CHR 2007 / Change of Layouts for MF and SP

Thierry MARTIN

28 April 2015

Muskrat Falls 315 kV Entire Site

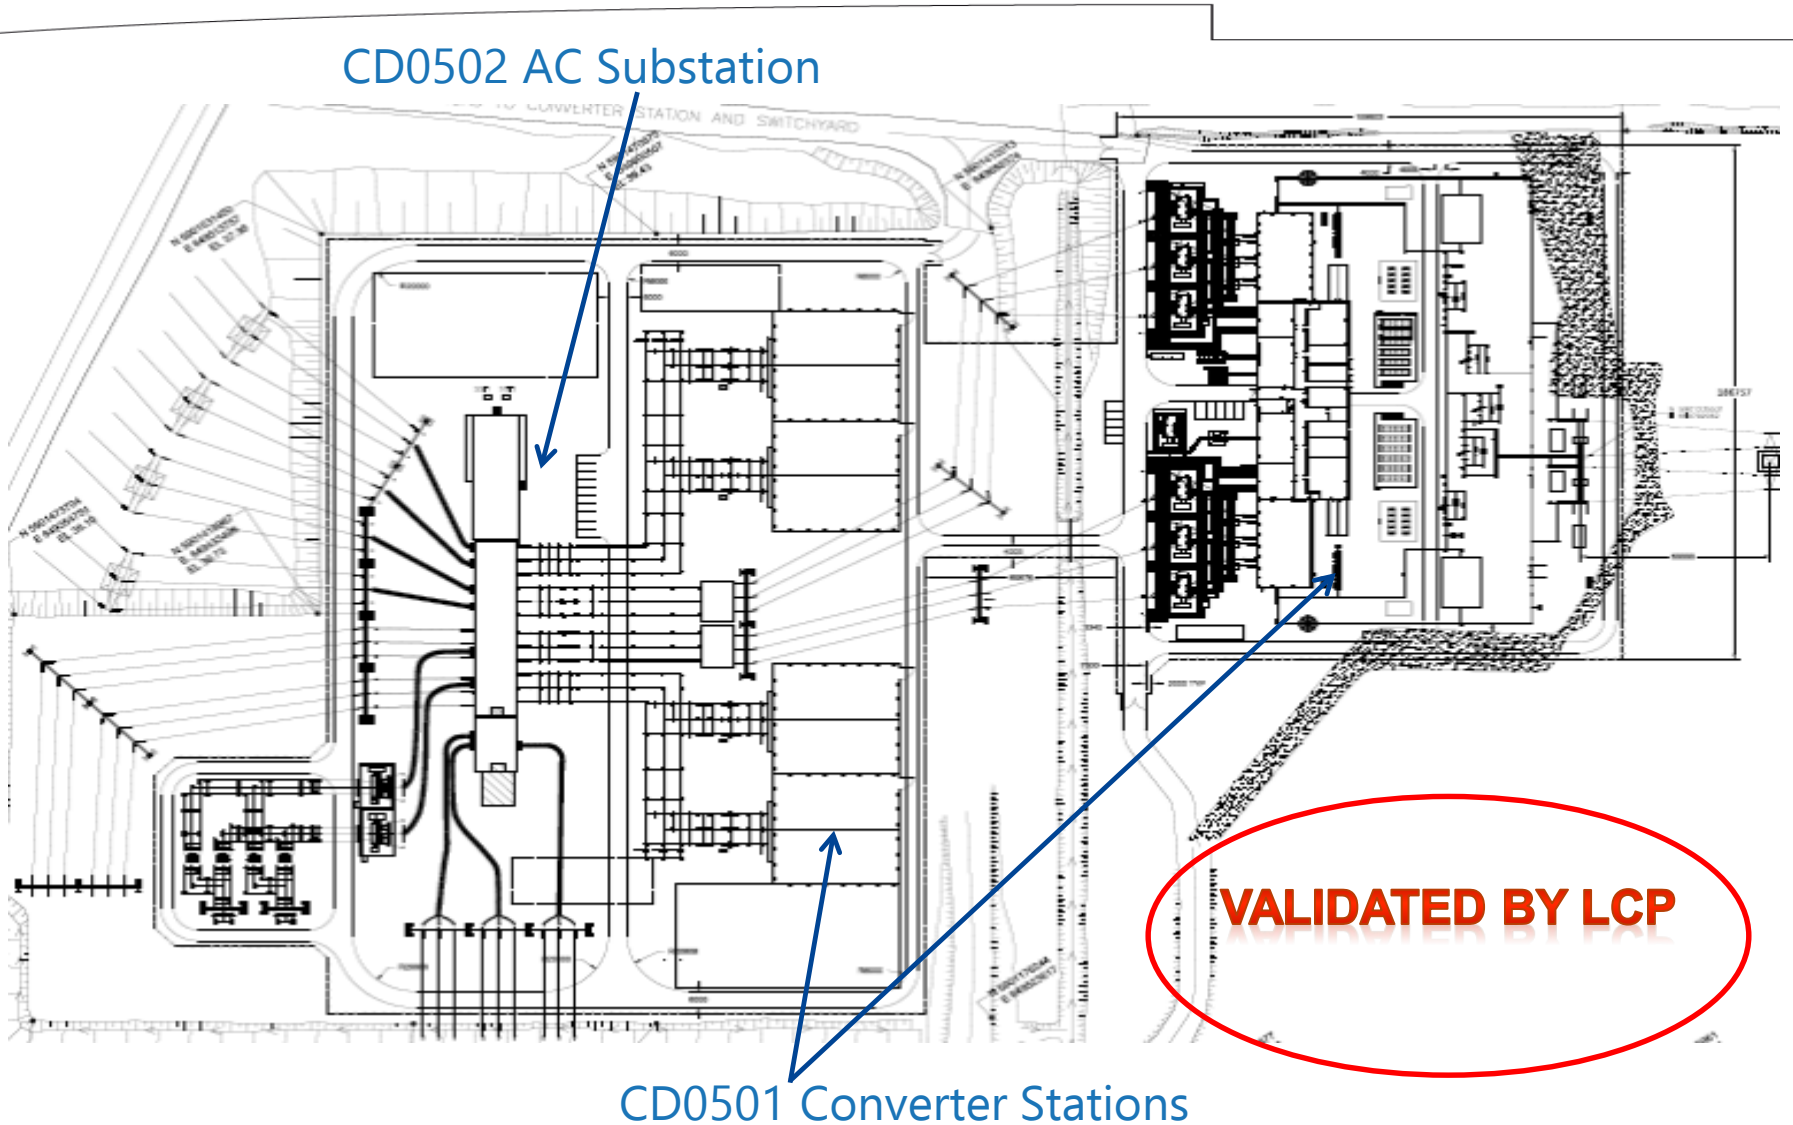
- Presence of weak soil
- Lower soil bearing capacity

- Smaller area than contractual for HVDC (296m instead of 336m).
- Difficult extension on each side due to presence of rocks for LCP site preparation.

- CHR-2007: this one
 - engineering time to define and validate the layouts with LCP. Period: end of Nov Jan 2015.
 - CW design for 150KPA soil condition.
 - costs impacts for equipment and related construction with 250KPA soil conditions (plus and minus).

VALIDATED BY LCP
